**Re: Susitna-Watana Hydroelectric Project, FERC Project No. 14241-000;
Study of Fish Passage Barriers Implementation Plan**

Study of Fish Passage Barriers Implementation Plan (June 2013)

Alaska Energy Authority Response to the June 7, 2013 Joint Comments of
National Marine Fisheries Service and U.S. Fish and Wildlife Service on
the Study of the Fish Passage Barriers Implementation Plan

Figure 5. Conceptual layout of 2-D coarse and fine mesh modeling within the proposed Whiskers Slough Focus Area.

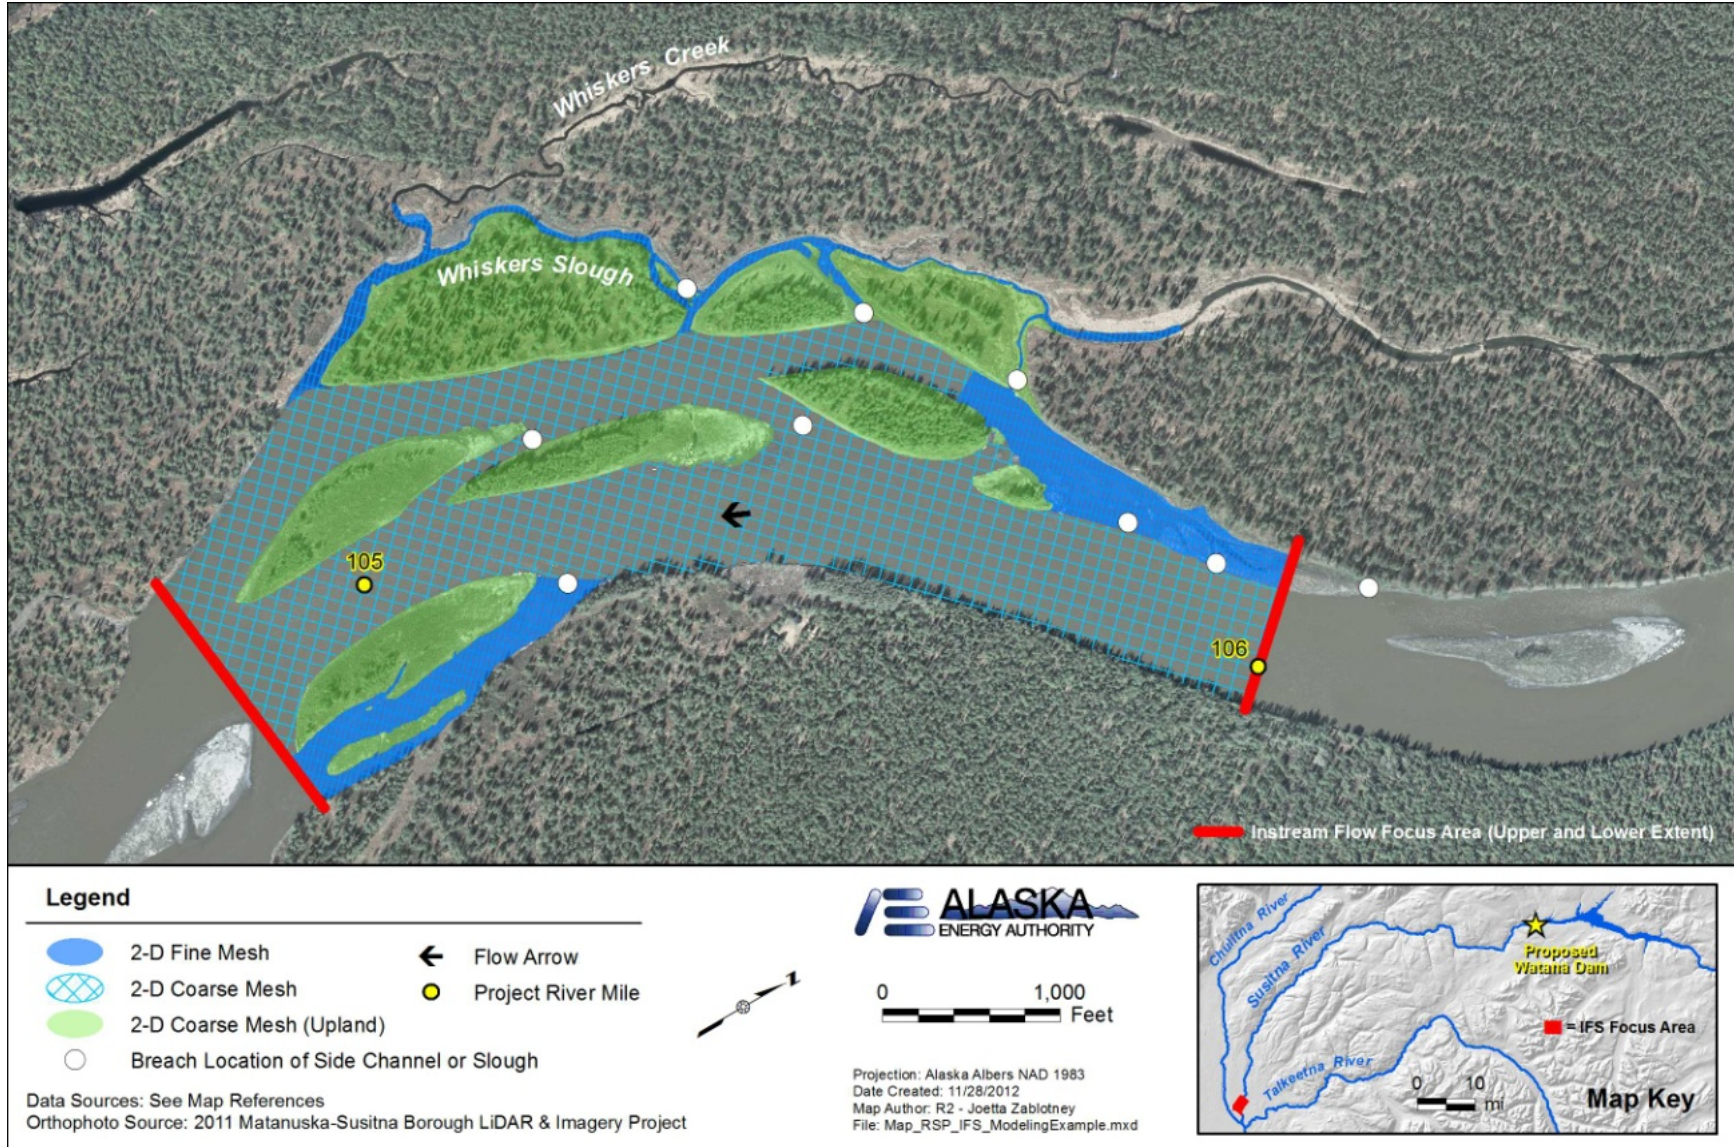
Comment	AEA Response
Section 7.3.2 Modeling Methods for Ice-Free Periods	
<p>14. <u>Recommendations</u></p> <p>Beaver dams within Focus Areas should be surveyed so that fish passage into and out of these important habitats can be assessed.</p>	<p>Beaver dams are transient and dynamic in the Susitna River, as they are in most large rivers. They are removed by high river flows, by ice, or are abandoned and deteriorate over time. The beaver dam may be partially removed by flow or ice and rebuilt within a matter of days, or alternatively, the dam may be completely removed and rebuilt in the future or never rebuilt. Beaver are opportunistic dam builders.</p> <p>As described in Section 7.5 of the Fish Passage Barriers Implementation Plan, AEA will survey all beaver dams encountered within the zone of hydrologic influence in select tributaries and Focus Areas as shown in Tables 1 and 2 of the Fish Passage Barriers Implementation Plan. Survey methods of beaver dams will follow those described in RSP Section 9.9, Section 9.12.4.4. Dimensions of the dam including height, length, and breadth, and depth of the leaping pool will be measured and observations of possible passage ways through or around the dam will be described. Photographs will be taken. The Fish Passage Barriers Implementation Plan at Section 7.3.2 has been modified to specify these methods at all beaver dams in Focus Areas.</p> <p>Because beaver dams are transient and dynamic, it is unlikely that this assessment will be material in analyzing potential Project effects.</p>
